THE GARDENS AT NORTH CAREFREE CONSTRUCTION DRAWINGS EL PASO COUNTY, STATE OF COLORADO

| GARDENS AT NORTH CAREFREE TITLE SHEET | |

**THE GARDENS AT NORTH CAREFREE
 PLAN AND PROFILE
 VINEYARD CIRCLE**

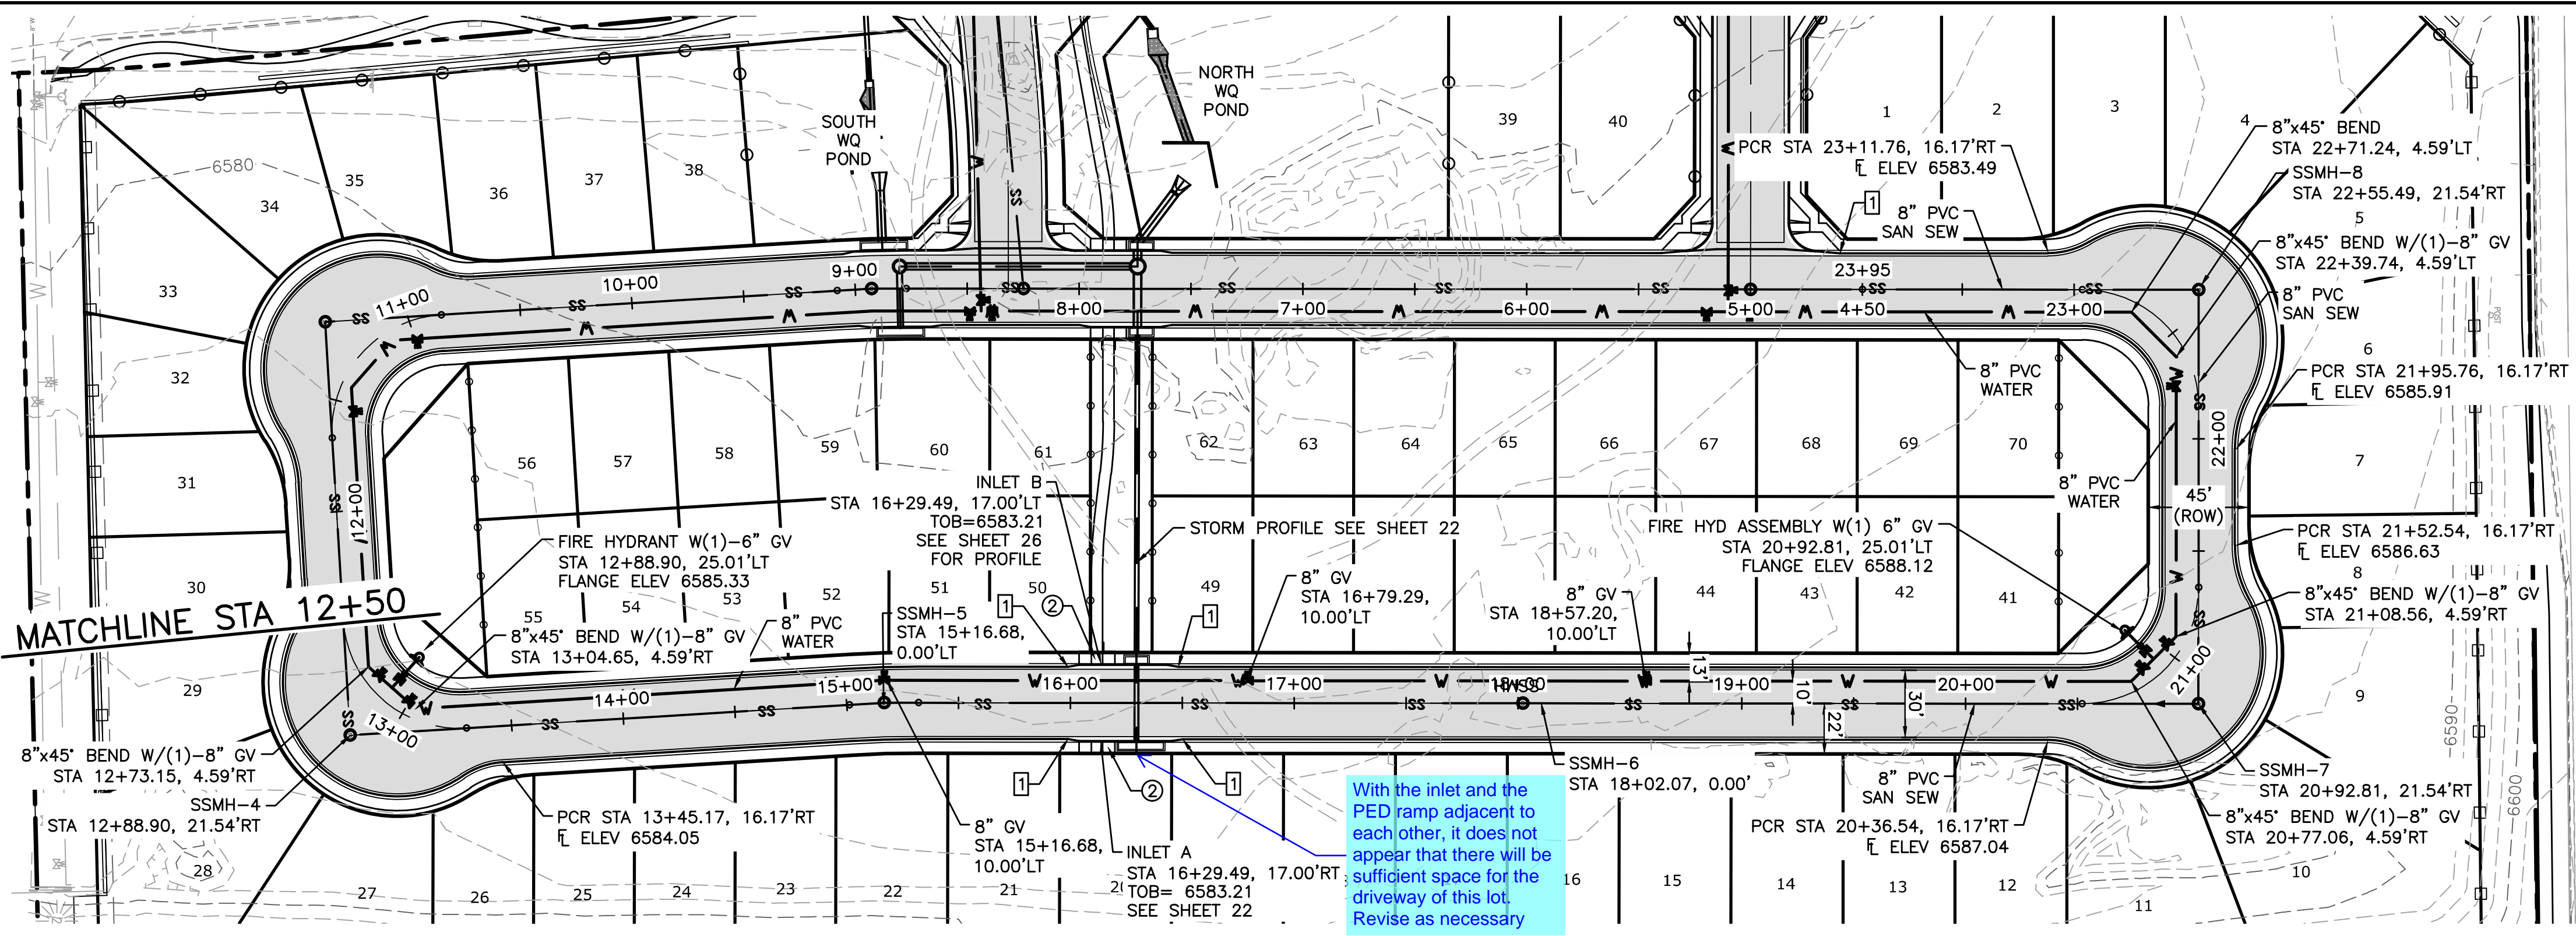
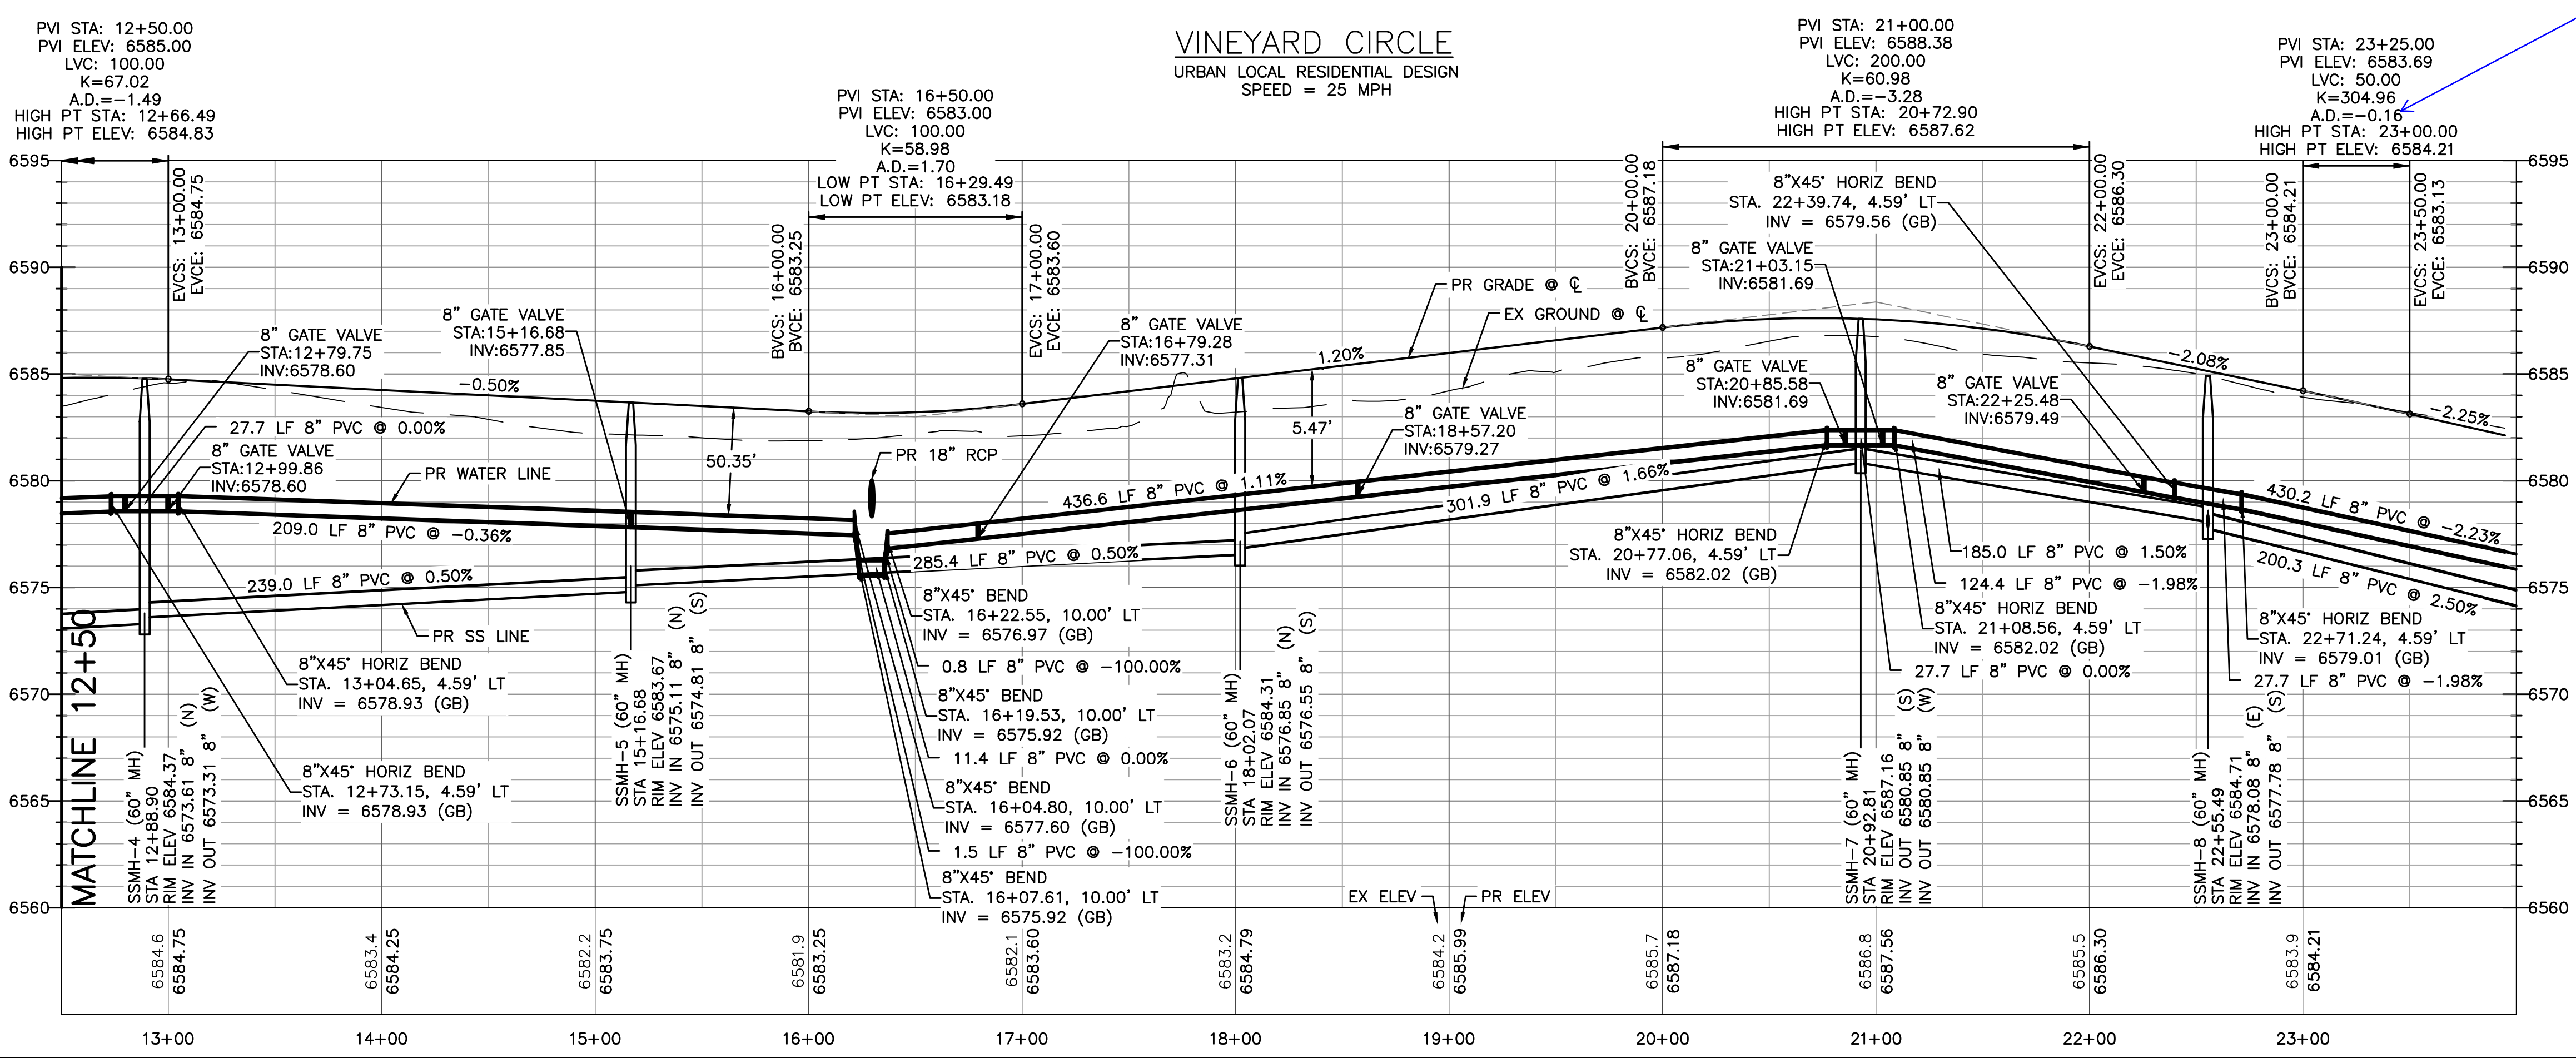
With the inlet and the PED ramp adjacent to each other, it does not appear that there will be sufficient space for the driveway of this lot. Revise as necessary

Note that per ECM 2.3.4.E vertical curves are only required when A.D. is equal to or greater than 1.0

**THE GARDENS AT NORTH CAREFREE
PLAN AND PROFILE
FALLOW LANE & RUNNING DEER WAY**

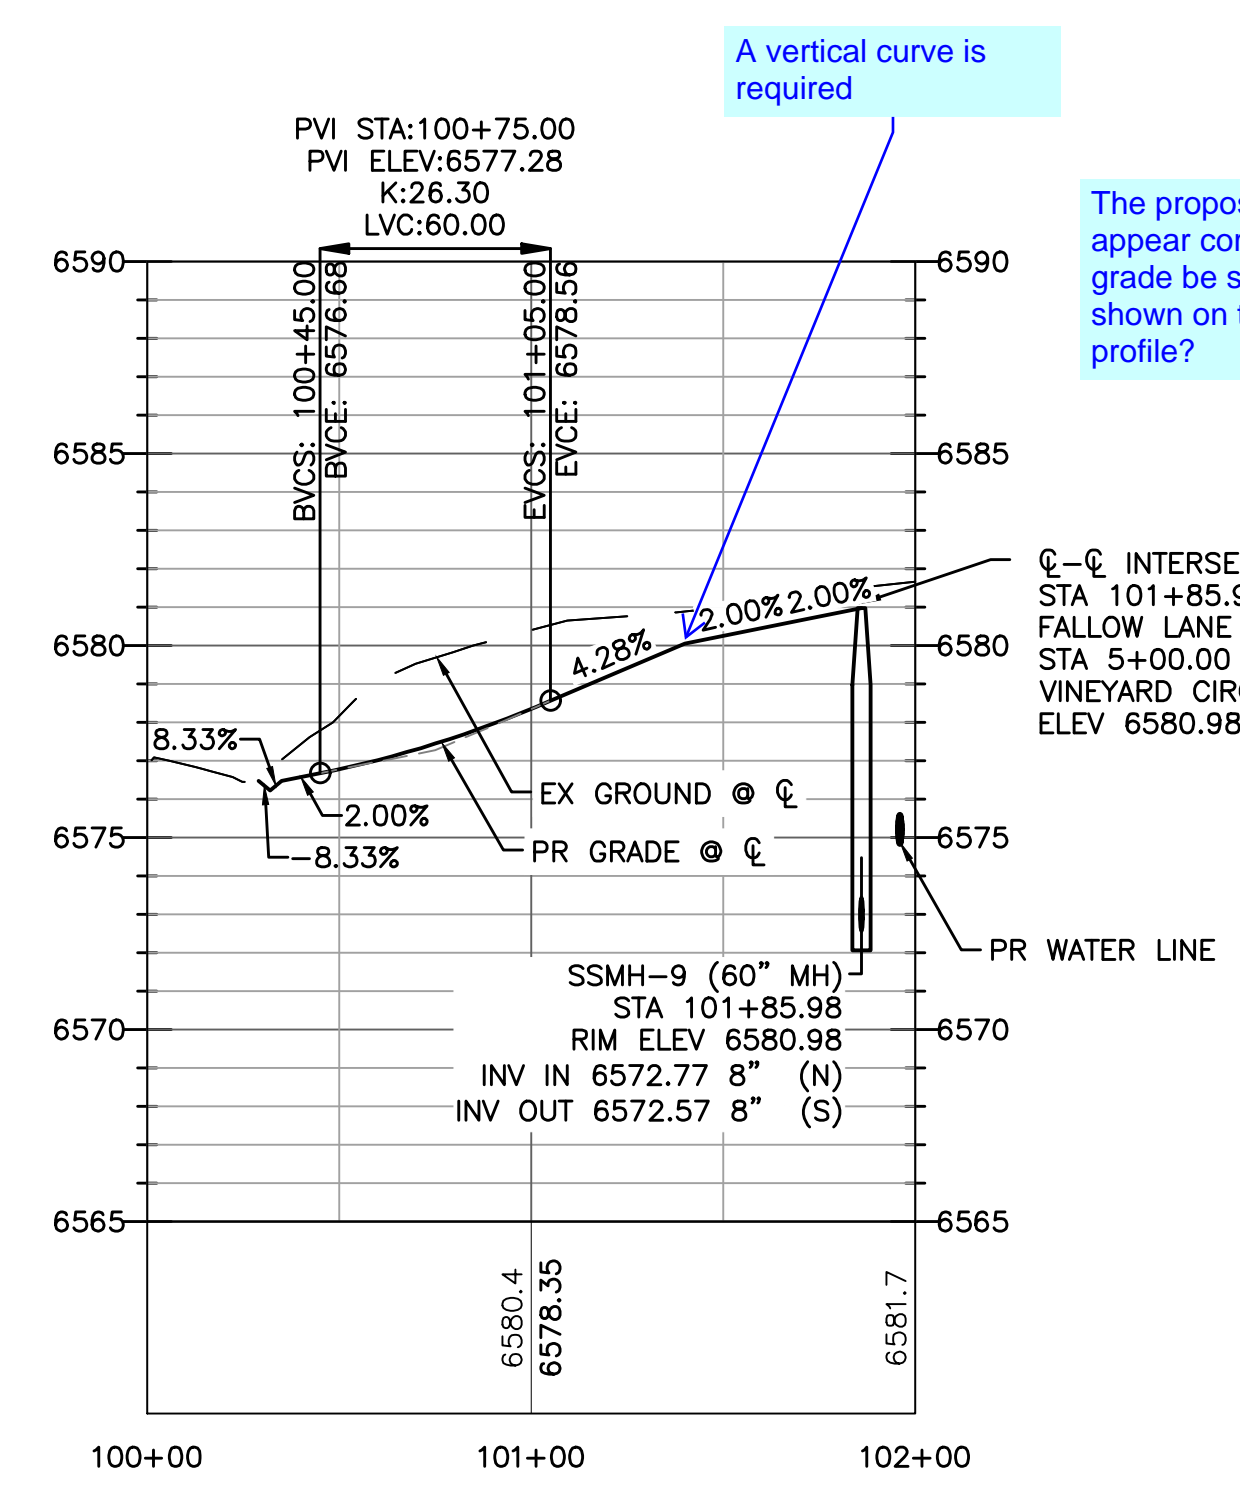
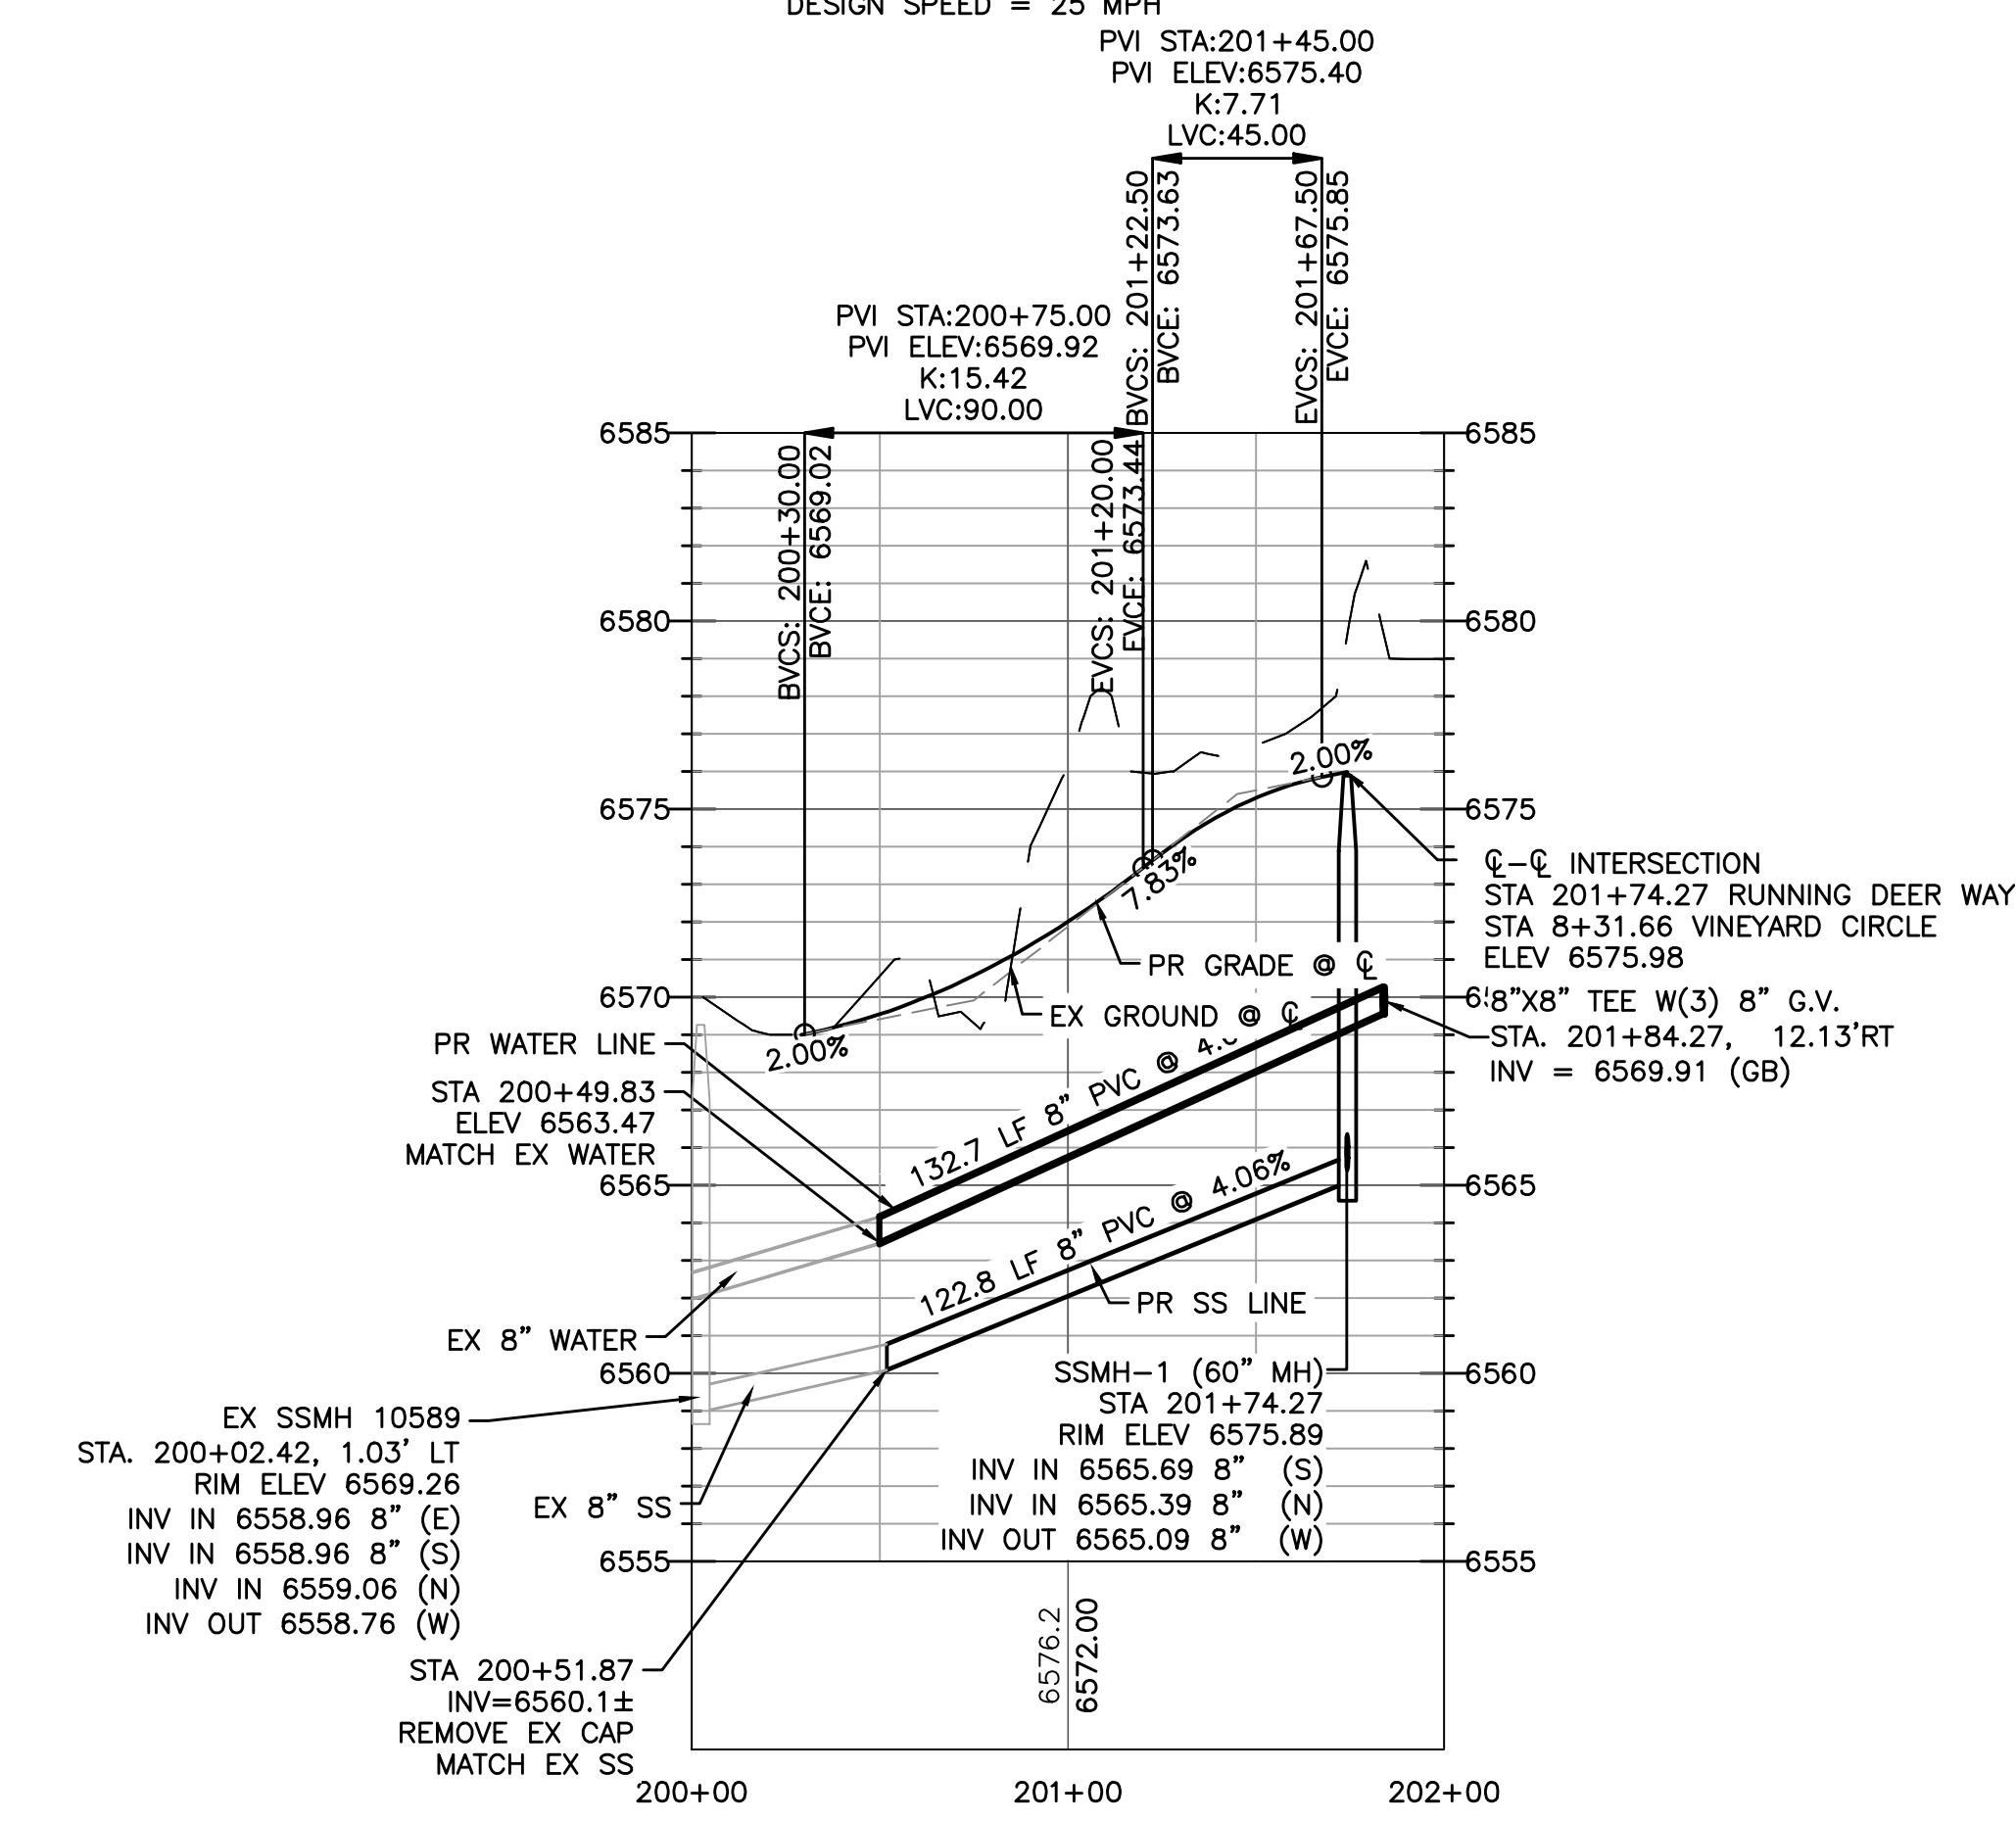
A vertical curve is required

The proposed grade doesn't appear correct. Shouldn't this grade be similar to the grade shown on the fallow lane road profile?
